BRIEFING SUMMARY SHEET

DEVELOPMENT ASSESSMENT CASE NUMBER: CD-2018-0008 – Austin Green

Presentation of a Project Assessment Report for the Austin Green Planned Unit Development, located at 11600-12337 Harold Green Road, within the Colorado River Watershed and the Elm Creek Watershed.

MASTER REVIEW REPORT

SUBJECT TRACT
 ZONING BOUNDARY

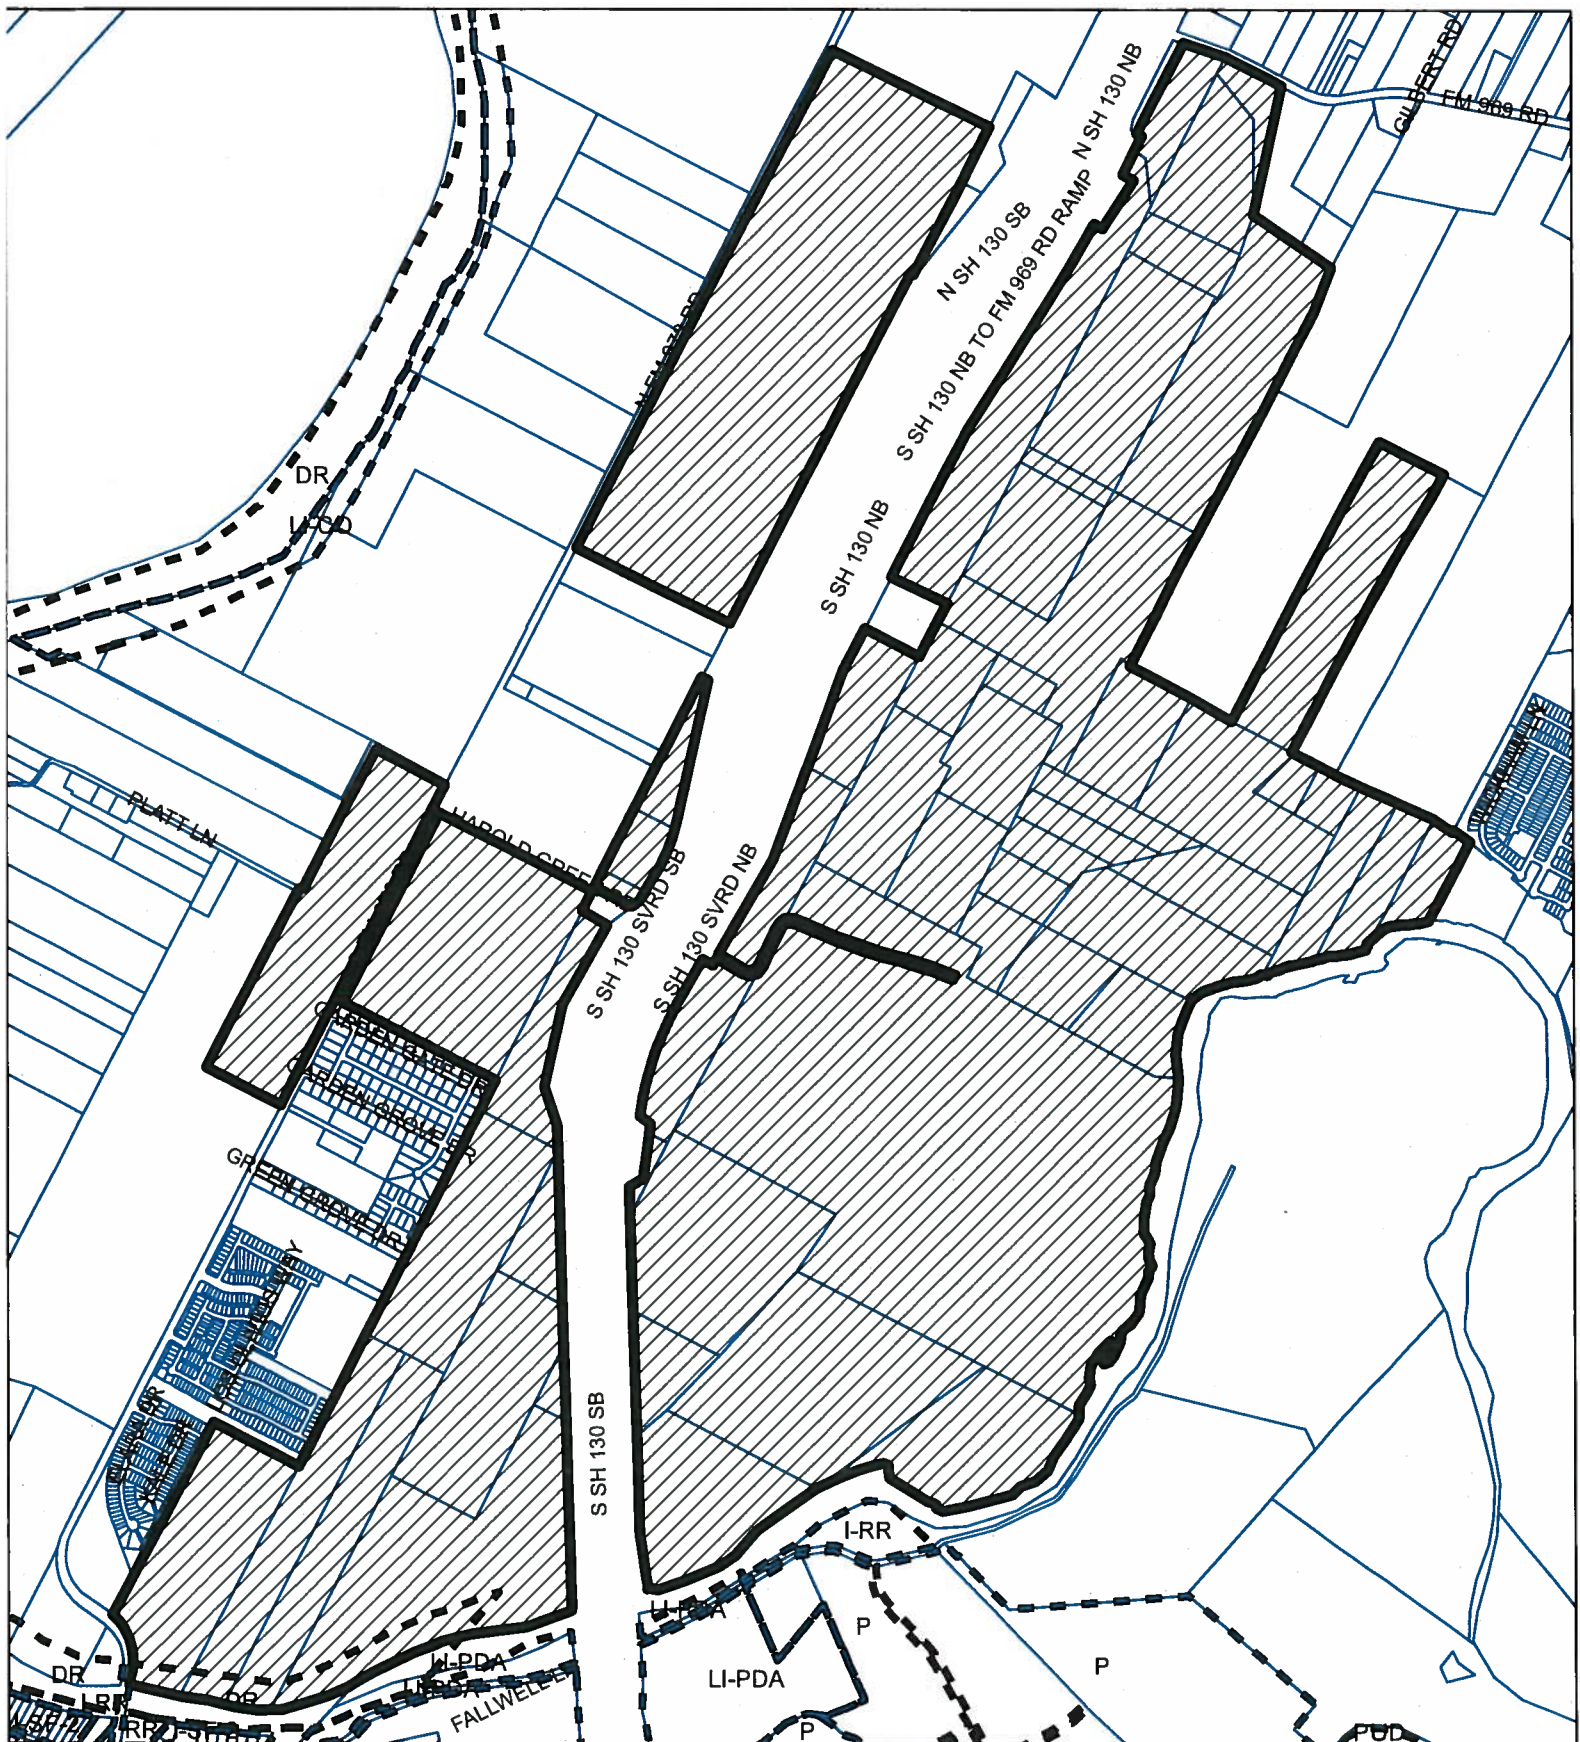
ZN 1. Retitle the Zoning Map to the Land Use Plan and add the following information with the PUD submittal:

- Add acreages associated with each district in the table at the left corner and within each specific area depicted on the plan
- Label Tracts 1-5 on the Land Use Plan and identify if these are associated with phases and general timing of development

- Provide a summary table showing the number of units or maximum square footage associated and development standards for each of the three land use categories and for each specific area. Which specific MU-1 tract(s) and land uses are proposed to have a maximum height of 120 feet? Staff will consider this height request when additional information is provided at the time of the PUD application.

- Delineate the jurisdictional lines of Travis County and the City of Austin
- Increase the font of the street names in order to provide better context of the project area

- Add a vicinity map to the Land Use Plan
